# **Cynllun Datblygu Lleol Diwygiedig Sir Gaerfyrddin 2018-2033**

PrC2/SS1 Pentre Awel

Datganiad Tystiolaeth

**PL/03877 - Discharge of Conditions 5 (Written Scheme of Investigation), 27 (Ecological Clerk of Works), 31 (Landscape Environmental Management Plan), 32 (Buffer Zone Scheme), 34 (Landscape Constraints Plan), 36 (Landscape Design Scheme) and 38 (Landscape Maintenance and Management) of S/36948 (Wellness and Life Science Development relating to Phase 1 only of the Outline planning permission S/36948**

Figure 13 Instability in Culvert at approximately 56hours

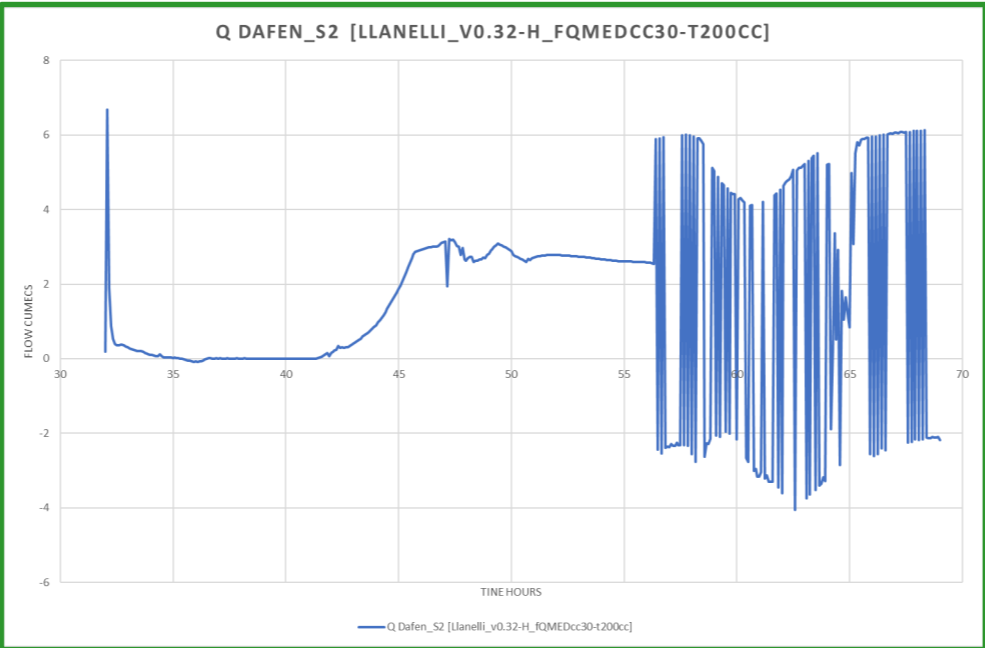
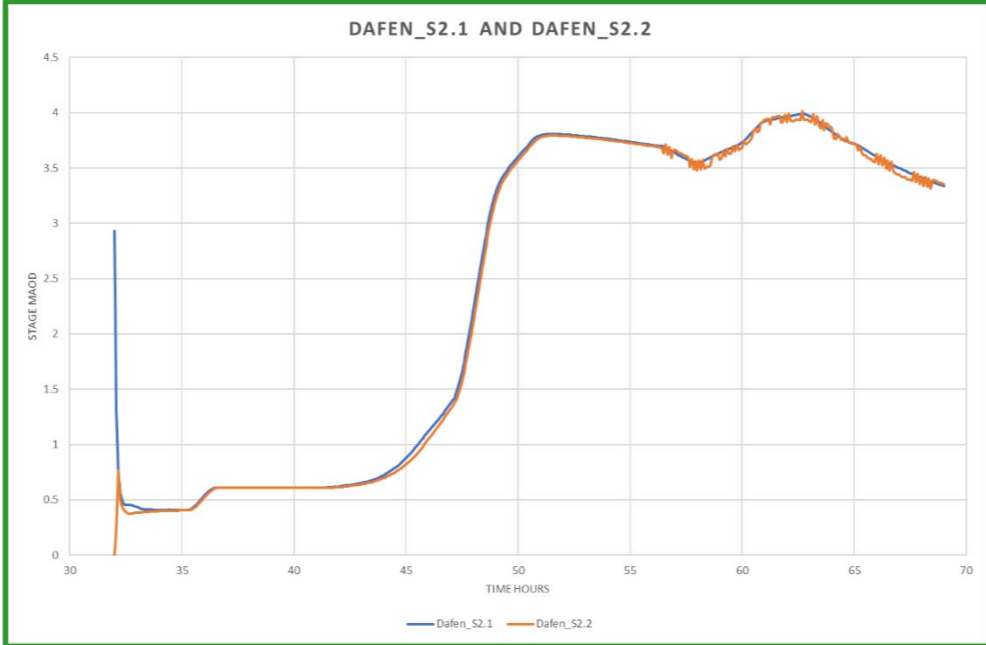
| Review Section |                                   | Response – EVY and NRW                                                                                                                                                                                                                                                                                                                                                                                                                                                                                                                                                                                                                                                                                                         | Subject Area                   | Assessment of impact of adopting NRW suggestions    |
|----------------|-----------------------------------|--------------------------------------------------------------------------------------------------------------------------------------------------------------------------------------------------------------------------------------------------------------------------------------------------------------------------------------------------------------------------------------------------------------------------------------------------------------------------------------------------------------------------------------------------------------------------------------------------------------------------------------------------------------------------------------------------------------------------------|--------------------------------|-----------------------------------------------------|
|                |                                   |  <p>Figure 14 Stage outputs showing instability on downstream end of culvert</p>                                                                                                                                                                                                                                                                                                                                                                                                                                                                                                                                                             |                                |                                                     |

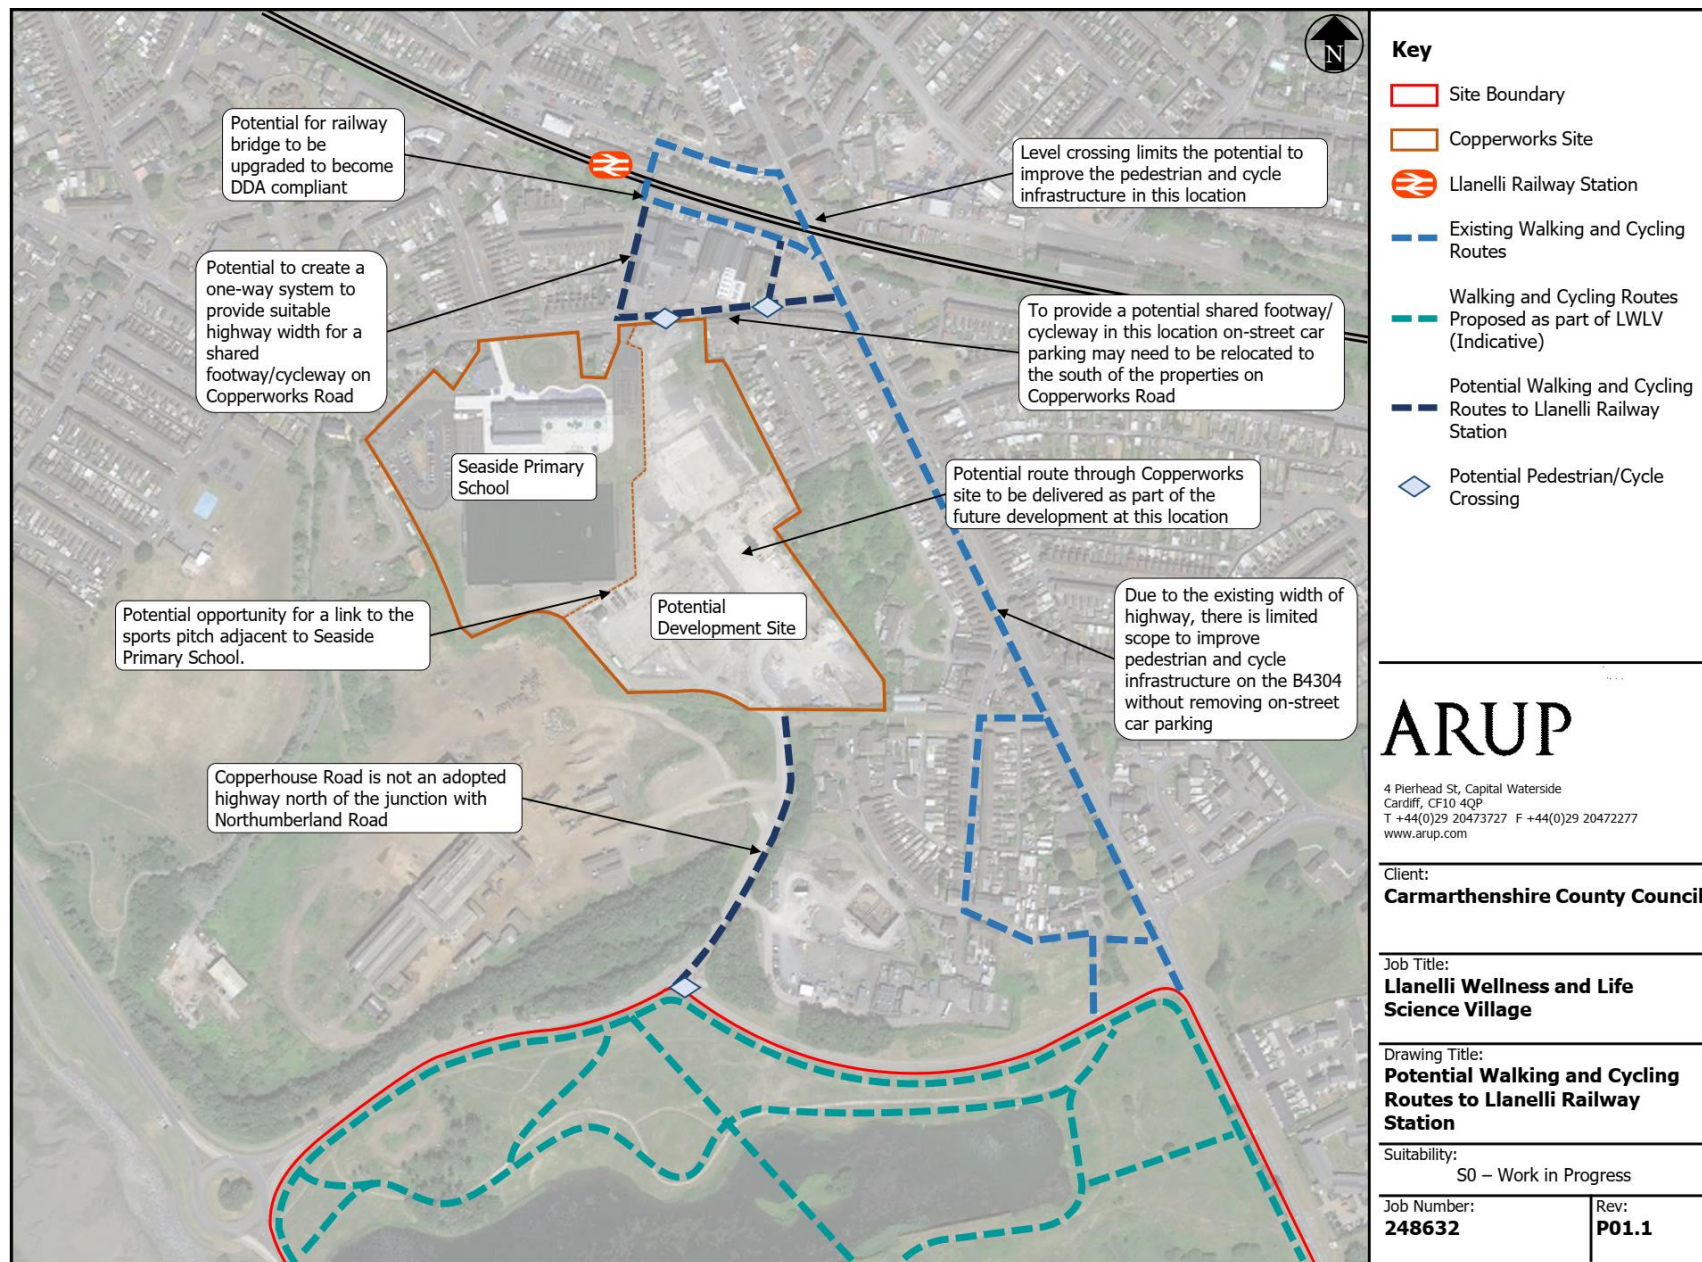
**It is unclear at this stage whether the signalised crossing directly west of the Delta Lakes Roundabout (as per the 4<sup>th</sup> bullet above) is to be provided or not. Clarification is therefore required on this matter. Furthermore, any crossing provided at this location would need to be a Toucan Crossing; accommodating both pedestrians and cyclists accessing the site from the coastal path.**
